RE: November 19, 2020 City Planning Commission Meeting, Item #3 - PLN20-310: Campus Bay Mixed-Use Project

I am writing in regard to the proposed Campus Bay Project development within the Richmond South Shoreline area (the "Project") and in response to the proposed addendum to the 2016 Environmental Impact Report (EIR) for the Richmond Bay Specific Plan. On behalf of San Francisco Baykeeper and our nearly 5,000 members and supporters who live around and enjoy the San Francisco Bay, I ask that you reject this addendum to the EIR and oppose development on this site until further remedial environmental action can be completed.

Figure 1: Richmond Campus Bay, featuring the Project area, as seen via airplane during low and high tide conditions to demonstrate hydrologic connectivity to the property and location of the high water mark.

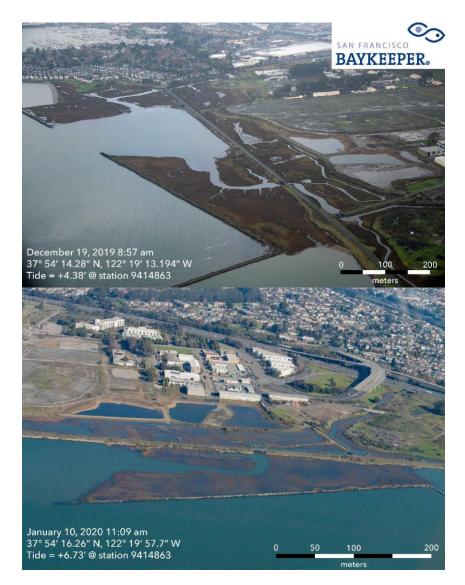
This, combined with aerial documentation of the site during high tide conditions (Figure 1), illustrates that the high water mark actually exists immediately adjacent to the Project area within the property boundary.

By observing the high water mark within Habitat Area 1, it becomes clear that the proposed development is partially within BCDC's 100-foot shoreline jurisdiction. As such, this shoreline parcel must adhere not only to the 2016 Richmond Bay Specific Plan⁴, but also to BCDC's 1977 South Richmond Shoreline Special Area Plan, which establishes that the Point Isabel Sub-Area within which the Project is contained will "[c]ontinue to accommodate special industrial, educational, and some commercial and recreational uses, but prohibit any residential development in the [area]."⁵ The Project cannot proceed as it has been presented in the EIR addendum without violating this policy. Until this discrepancy is effectively resolved, the plans currently before this Planning Commission do not accurately reflect the Project as it will appear in its final form. The most likely outcome is that residential development must be moved out of the 100-foot shoreline band before proceeding.
